**STAFF RECOMMENDATION**  
**1430-B Greenwood Avenue**  
**September 20, 2017**

**Application:** New construction – infill and outbuilding  
**District:** Eastwood Neighborhood Conservation Zoning Overlay  
**Council District:** 06  
**Map and Parcel Number:** 08302037100  
**Applicant:** Sathan LLC  
**Project Lead:** Paul Hoffman, paul.hoffman@nashville.gov

<p><b>Description of Project:</b> Application for new residence with detached outbuilding.</p> <p><b>Recommendation Summary:</b> Staff recommends approval with the conditions:</p> <ol style="list-style-type: none"> <li>1. Lap siding shall have a five inch (5”) reveal;</li> <li>2. The finished floor height shall be consistent with the finished floor heights of the adjacent historic houses, to be verified by MHZC staff in the field;</li> <li>3. Staff approve the final details, dimensions and materials of windows and doors prior to purchase and installation;</li> <li>4. The HVAC shall be located behind the house or on either side, beyond the mid-point of the house; and</li> <li>5. Staff approve the roof color and masonry color, dimensions and texture.</li> </ol> <p>Staff finds that the proposed application meets Section II.B fo

① FRONT (NORTH) ELEVATION

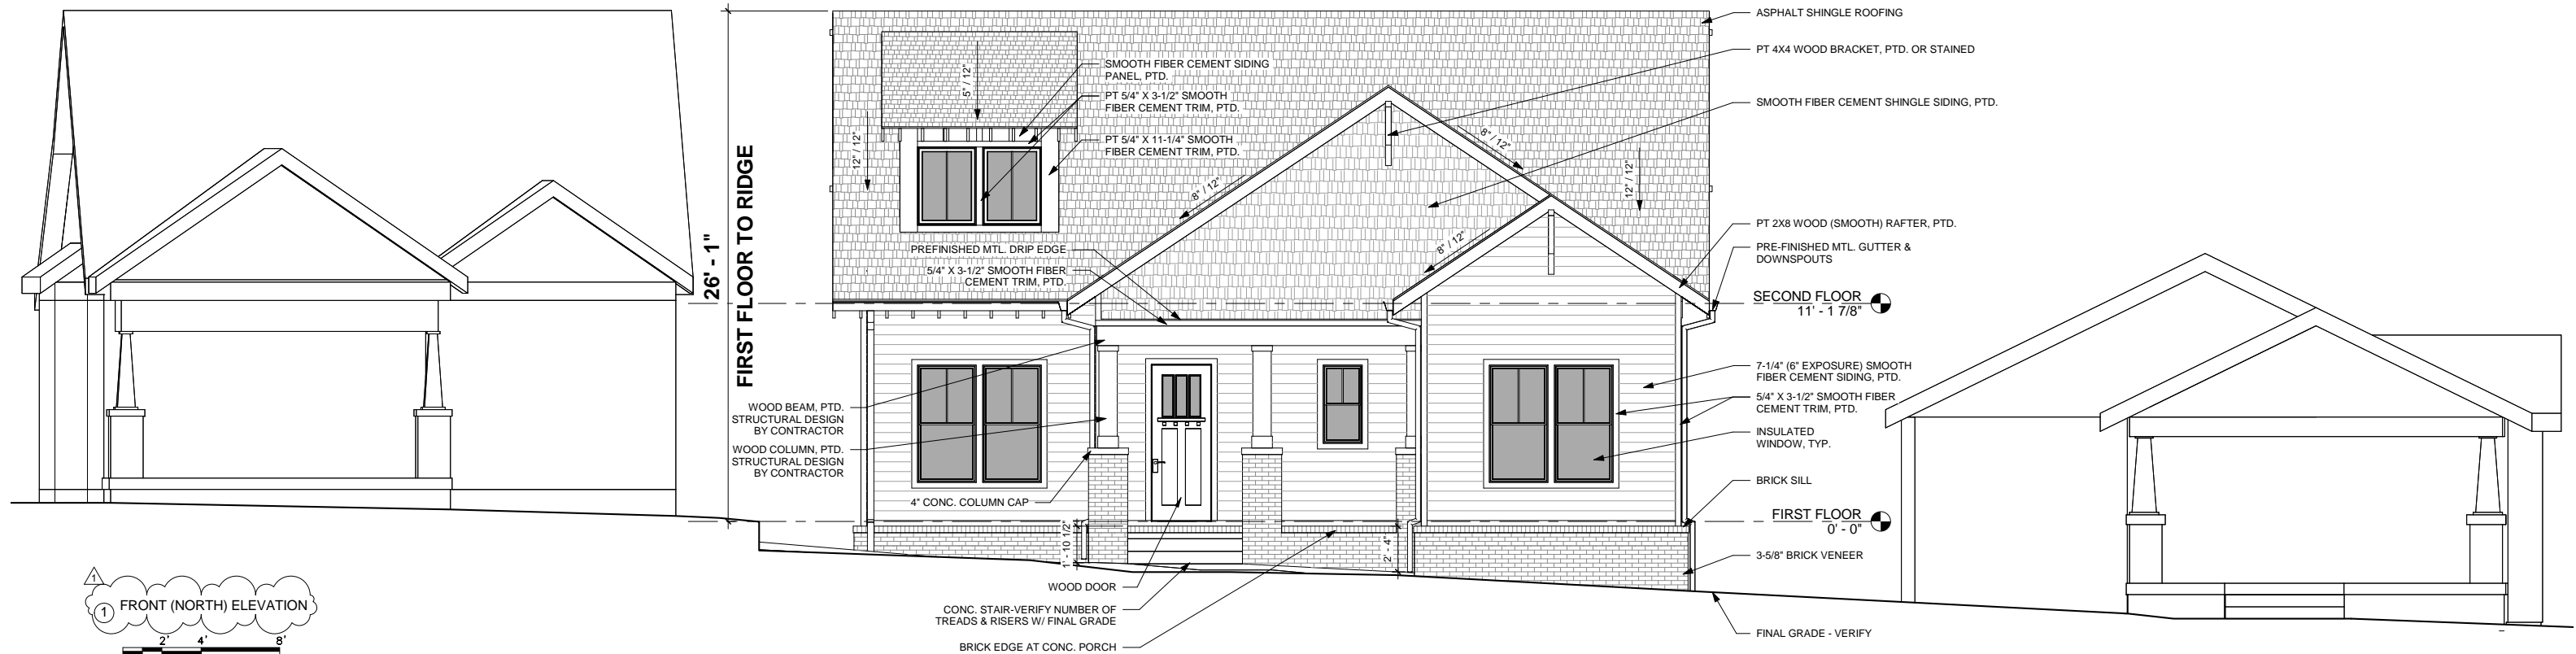
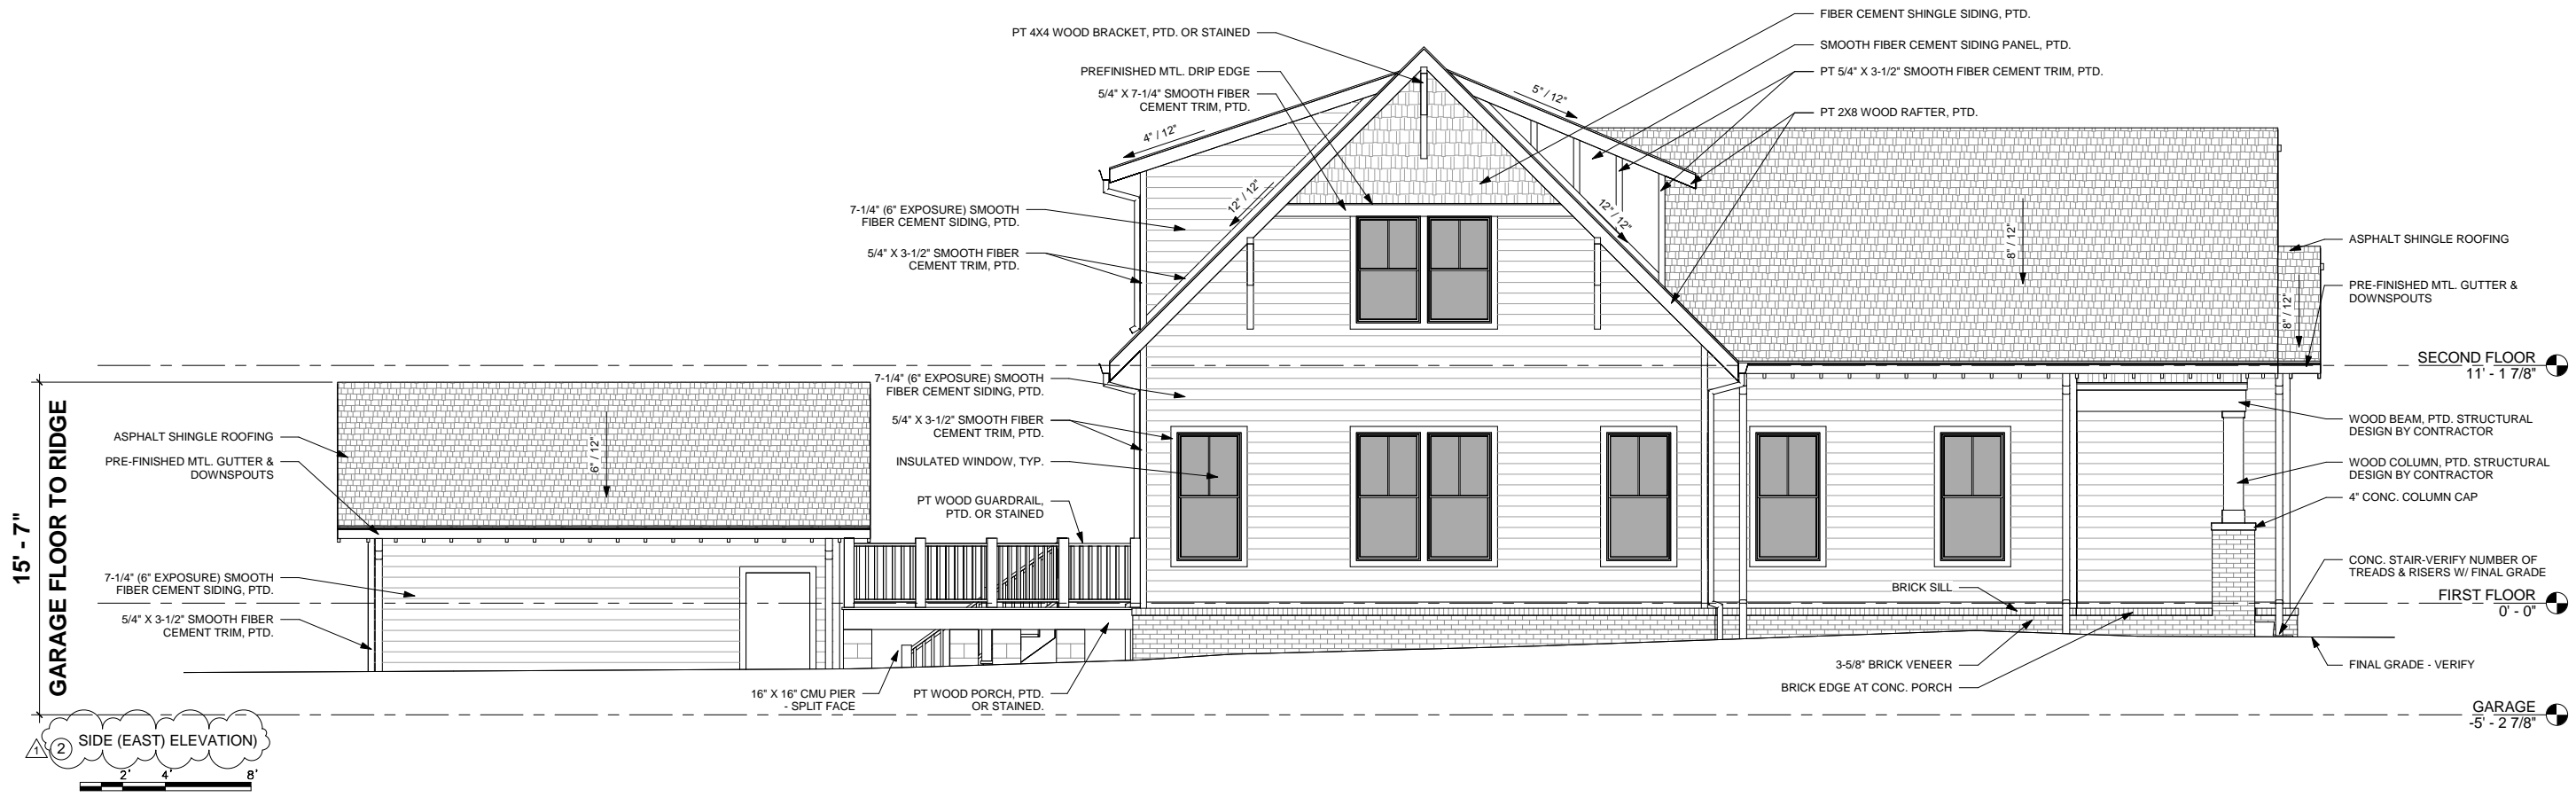
The new building is proposed with smooth-faced fiber-cement siding with six inches (6”) reveal. The guidelines allow for a reveal greater than five inches (5”) and up to eight inches (8”) when corners are mitered. However, as the proposed building has corner boards, it is Staff’s recommendation that the siding have no more than a five inch (5”) reveal. The foundation will be brick; Staff asks for approval of the masonry prior to purchase and construction. Details of windows and doors were also not specified; Staff asks to approve the final window and door selections prior to purchase and installation. With the staff’s final approval of the roofing color, masonry, windows and doors, the application meets section II.B.1.d for materials.

Proportion and Rhythm of Openings: The windows are approximately twice as tall as they are wide, meeting the historic proportion of openings. There are no large expanses of wall space without a window or door opening. Staff finds the project’s proportion and rhythm of openings meets Section II.B.1.g.

1. Lap siding shall have a five inch (5”) reveal;
2. The finished floor height shall be consistent with the finished floor heights of the adjacent historic houses, to be verified by MHZC staff in the field;
3. Staff approve the final details, dimensions and materials of windows and doors prior to purchase and installation; and,
4. The HVAC shall be located behind the house or on either side, beyond the mid-point of the house; and
5. Staff approve the roof color and masonry color, dimensions and texture.
